RAAF ADDITION  
SEDGWICK COUNTY, KANSAS

S/D 98-46 - Revised One-Step Final Plat of RAAF ADDITION

S/D 98-46 - Revised One-Step Final Plat of RAAF ADDITION

CASE NUMBER: S/D 98-46 - RAAF ADDITION

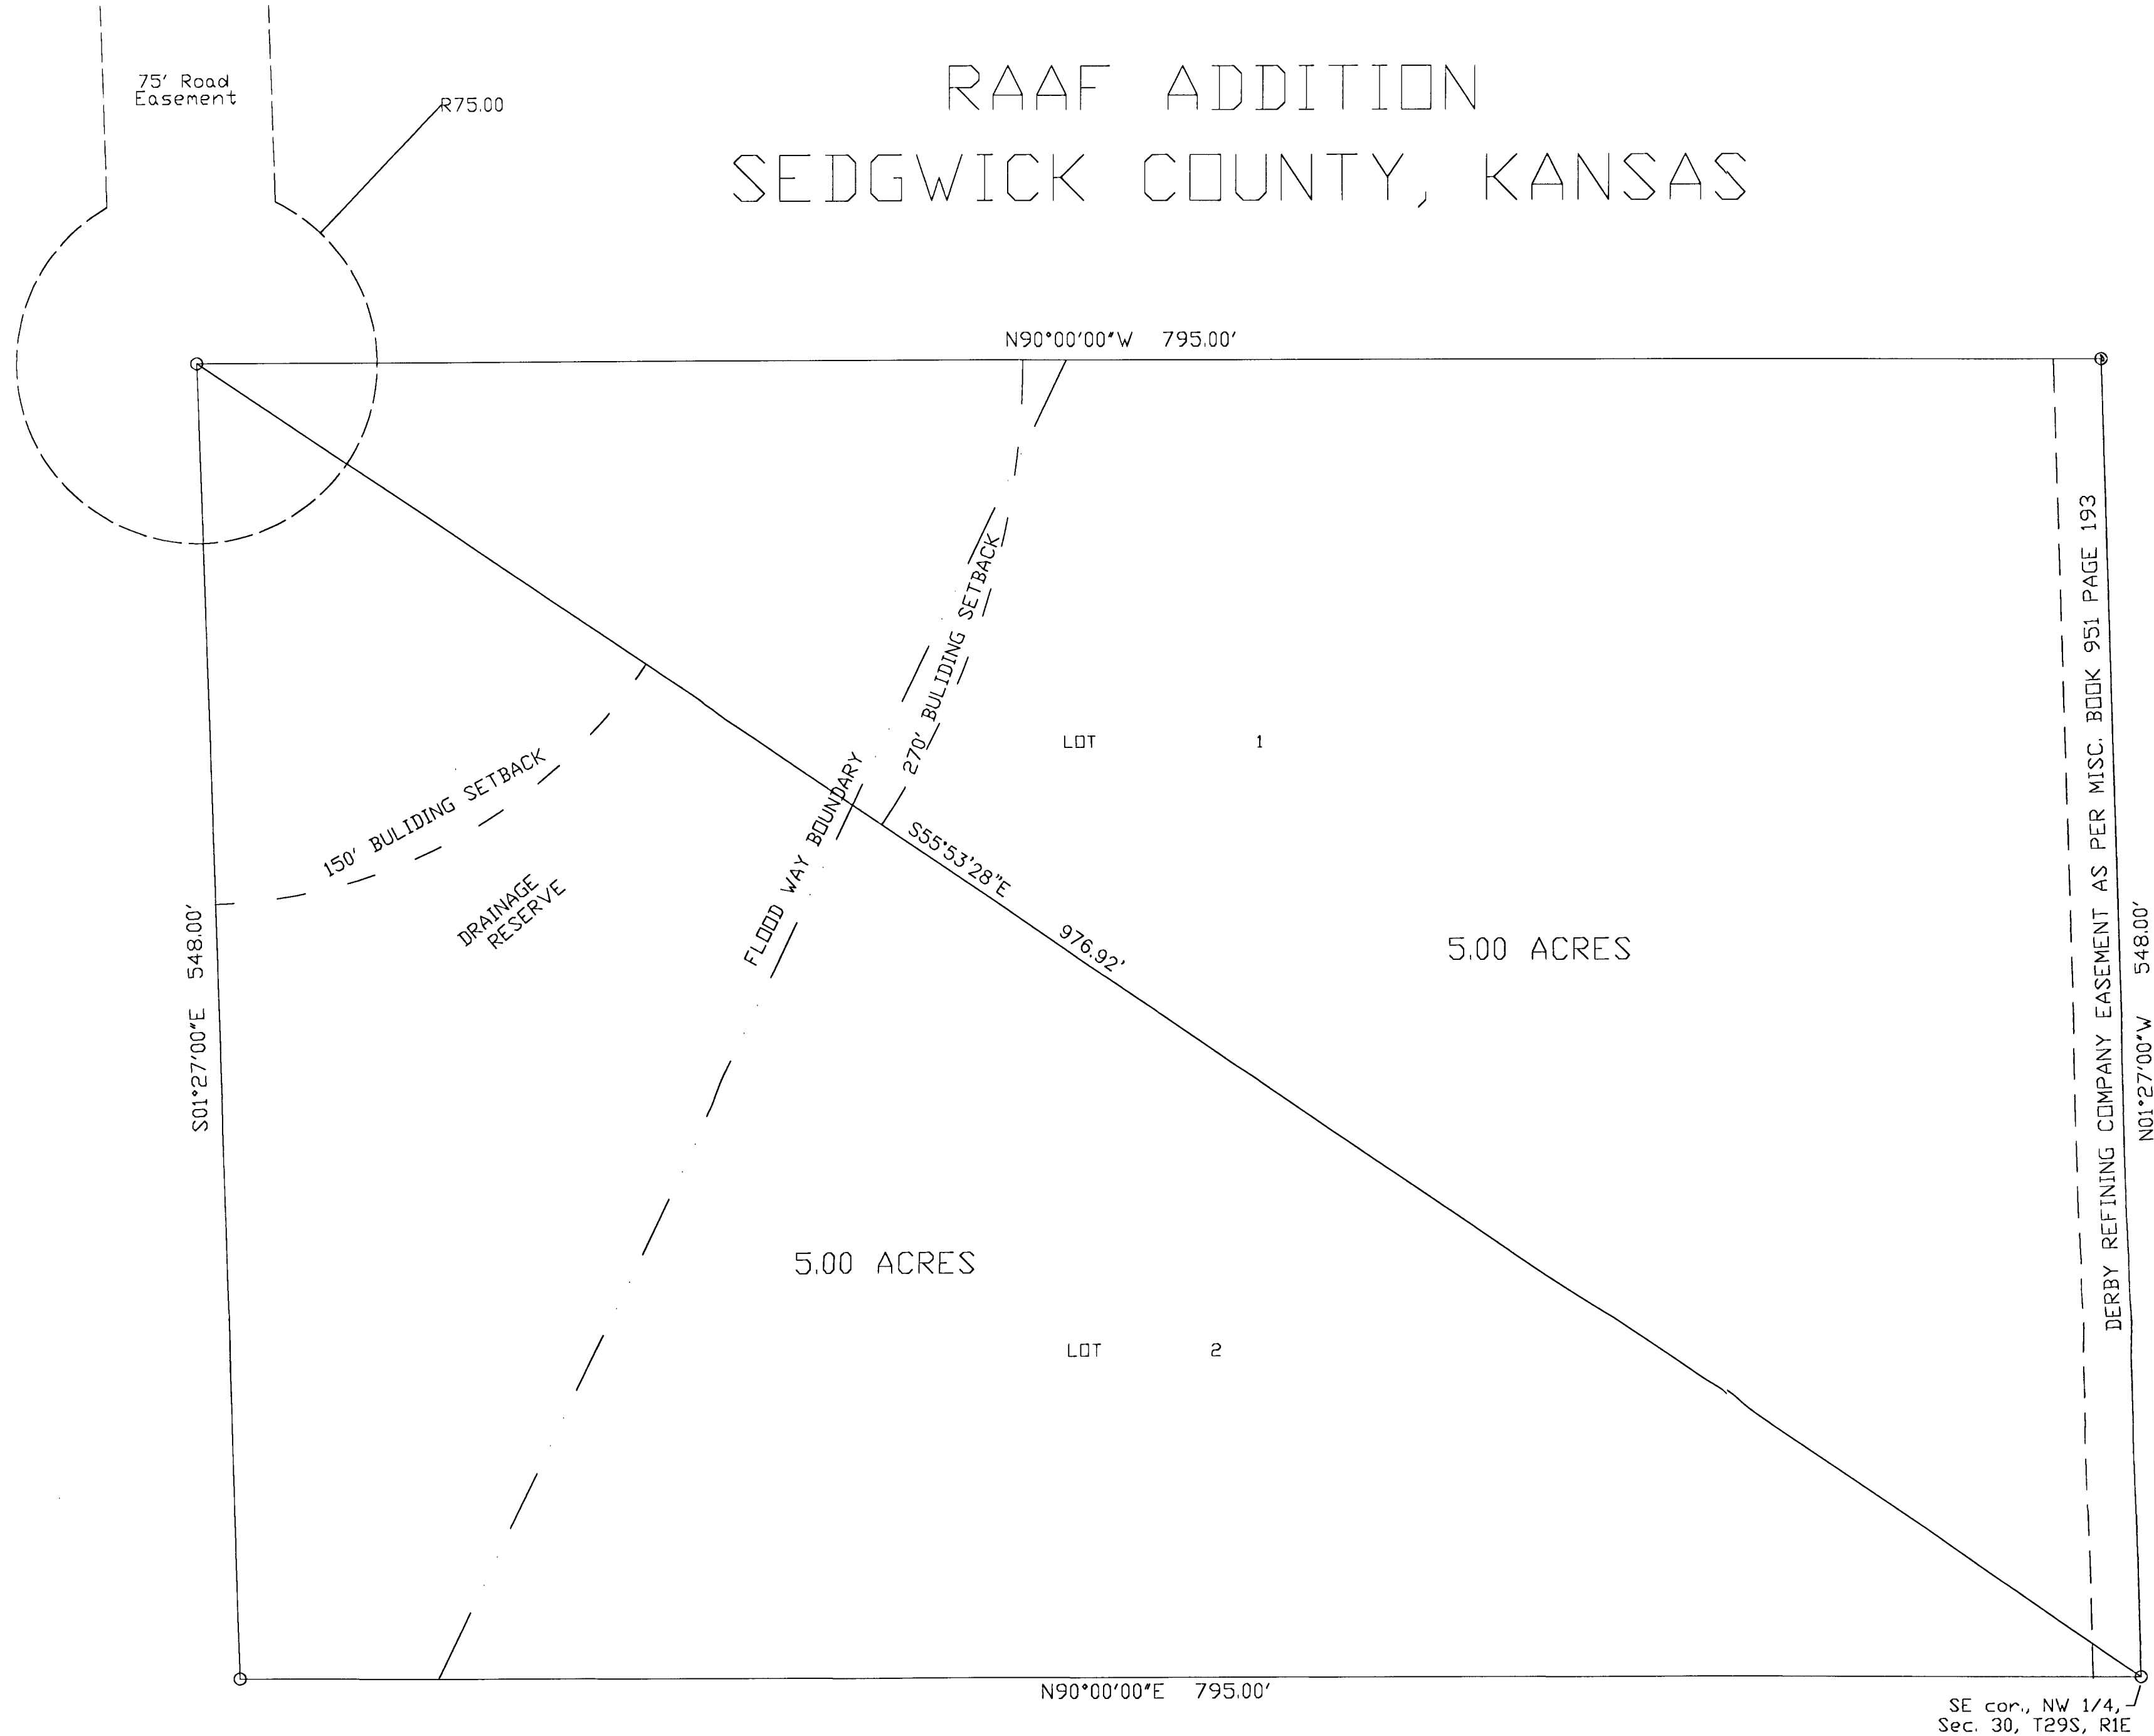
- E. The platting binder indicates two pipeline easements which are not denoted on the plat. Verification must be provided by the pipeline companies that both pipeline easements are located off-site or have been released.

- F. Lot 1 does not conform with the 200-foot lot width requirement of the RR district. An increase in the distance of the building setback from the road would enable the lot to meet the standard.

- G. The dimension for the west line of the plat does not correlate with the legal description and should be corrected on the final tracing.
- H. The applicant shall install or guarantee the installation of all utilities and facilities which are applicable and described in Article 8 of the MAPC Subdivision Regulations. (Water service and fire hydrants required by Article 8 for fire protection shall be as per the direction and approval of the Chief of the Fire Department.)

- A. Since neither municipal water nor sanitary sewer is available to serve this property, the applicant shall contact the Environmental Health Division of the Health Department to find out what tests may be necessary and what standards are to be met for approval of on-site sewerage facilities and water wells. A memorandum shall be obtained specifying approval. Both proposed lots (4.9 + acres) contain less than the minimum five (5) acres required for the use of a sewage lagoon, and will necessitate a waiver granted by the Subdivision Committee. **Standard soil testing is required.**

- C. County Engineering needs to comment on the status of the applicant's drainage plan. **The drainage plan is approved.**
- D. County Fire and County Engineering need to comment on access requirements since it appears access is obtained through a road easement close to a half mile in length. **County Engineering requests a copy of the private maintenance agreement for the abutting road. County Fire has required the installation of a rock surface for the turnaround.**

- E. The platting binder indicates two pipeline easements which are not denoted on the plat. Verification must be provided by the pipeline companies that both pipeline easements are located off-site or have been released.

- F. Lot 1 does not conform with the 200-foot lot width requirement of the RR district. An increase in the distance of the building setback from the road would enable the lot to meet the standard.

- G. The dimension for the west line of the plat does not correlate with the legal description and should be corrected on the final tracing.
